# Analysis of the Duke Energy 2020 Integrated Resource Plans

This memorandum is prepared for the North Carolina Attorney General's Office (AGO) and summarizes Strategen Consulting, LLC's<sup>1</sup> review of the 2020 Integrated Resource Plans that were submitted by Duke Energy Carolinas (DEC) and Duke Energy Progress (DEP) (referred to collectively as Duke). The memorandum provides analysis supporting Strategen's conclusions, along with recommendations to the North Carolina Utilities Commission (Commission) regarding three, core topics, which are summarized below:<sup>2</sup>

Figure 1. Chart derived from combined data found in Tables 11-A and A-11 in the 2020 IRPs.<sup>7</sup>

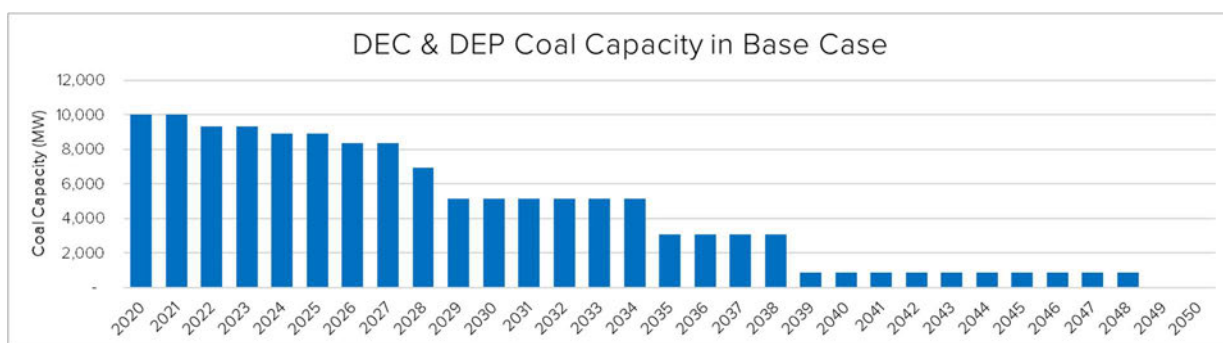
Strategen's analysis indicates that several of Duke's proposed retirement dates would extend the operation of certain coal assets well beyond what may be in the financial best interest of Duke's customers. Furthermore, the process by which Duke selected these retirement dates is flawed and deviates from sound planning principles. Finally, continuing to operate these assets for an extended period of time is inconsistent with the spirit of Governor Cooper's Executive Order No. 80<sup>5</sup> and the North Carolina Clean Energy Plan.<sup>6</sup>
